M.J.T.P.C. File No.:	25-17-MSDP	Date of Receipt/Filing:	December 1, 2025
School District:	X Donegal		Elizabethtown

# FINAL MINOR SUBDIVISION PLAN

### LANCASTER FARM SANCTUARY

Re: Lancaster Farm Sanctuary  
Final Minor Subdivision Plan  
Township Permit No. 25-17-MSDP  
LCEC Project No: 25-205

**SUBDIVISION PLAN**

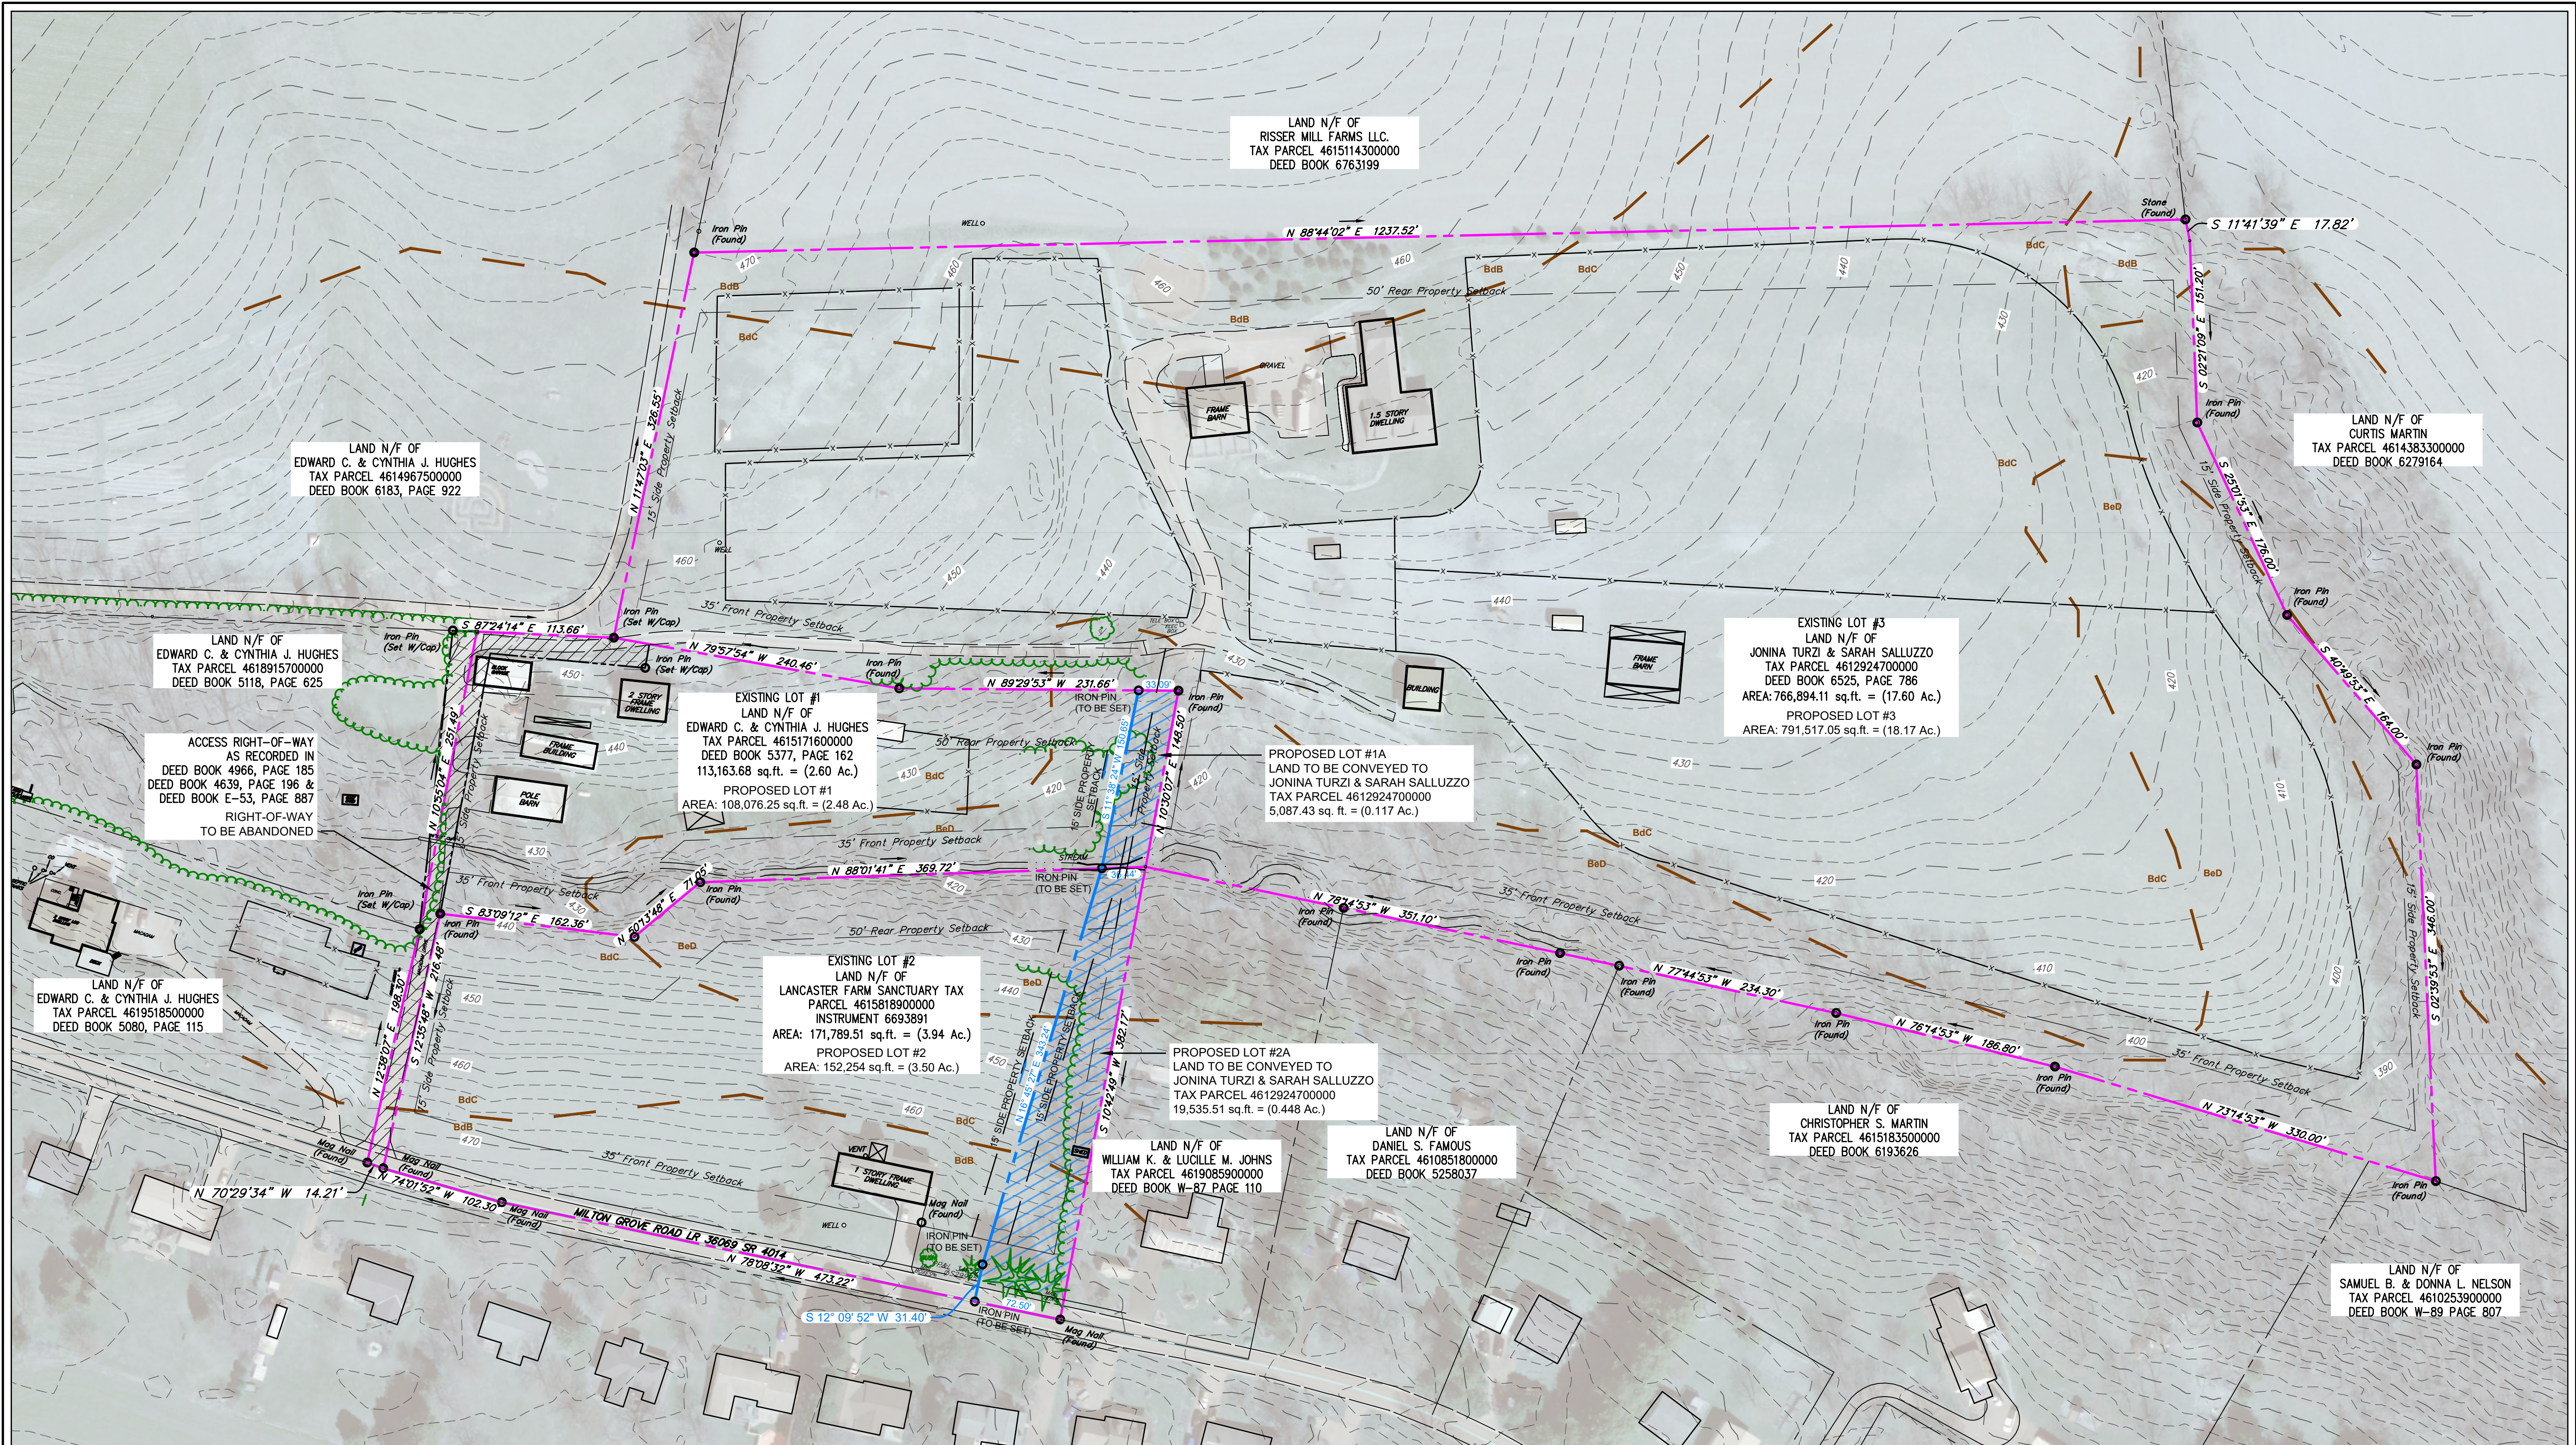
1. The "Agritourism" use shall be added to the Zoning/Site Data table on Sheet 2 of the plans for Existing and Proposed Lots #1 and #3 (135-82.H).
2. The number of lots which may be created from a parent tract is limited by Section 135-85.B of the Zoning Ordinance based upon the size of the parent tract. The size of the parent tract as it existed on June 4, 1978 shall be used in determining the number of lots which may be created from the parent tract (135-85.B(3)). The plans shall specify which lot or lots shall carry with it any remaining rights of further subdivision or erection of single-family dwellings or other principal nonagricultural buildings. This shall also be included in the deeds for each lot (135-85.B(6)).

3. The minimum (1 acre) and maximum (2.5 acres) lot areas for single-family dwellings shall be added to the Zoning/Site Data tables (135-85.C(1)&(2)).
4. The area of Existing Lot #2 exceeds the maximum lot area for single-family dwellings. This is an existing non-conformity and the proposed subdivision is improving this non-conformity (135-85.C(2)).

5. The minimum lot width listed in the Zoning/Site Data tables shall be 100' (135-85.D).

6. The minimum side yard setback listed in the Zoning/Site Data tables shall be 20' (135-85.G).
7. The minimum side yard accessory setback listed in the Zoning/Site Data tables shall be 10' (135-86.C).

18. The names and plan book record numbers of all adjacent landowners shall be shown on the plan, including those across existing rights-of-way (119-31.C(2)). The landowner on the western side of Existing Lot #2 shall be corrected.

19. Existing features within 200 feet of the subject tract shall be shown on the plans (119-31.C(3) & 113-43.I(5)).
20. The dimensions of existing rights-of-way and cartways for Milton Grove Road and the dimension of the existing driveway on Lot #3, shall be added to the plan (119-31.C(3)(a)).

23. The side yard setback lines for Existing Lot #3 within the flag pole should be deleted (119-31.D(5) & 135-320.D). (All areas of the pole are within the front yard (119-320.D(1)).

24. The "Minimum Lot Areas" shown on Sheet 2 of the plans should distinguish between net and gross lot area (119-31.D(9)).

27. The lot areas listed in the Zoning/Site Data tables for Existing Lot #2 are inconsistent with the lot areas shown on the plans for Existing Lot #2 (119-35.D(2)).
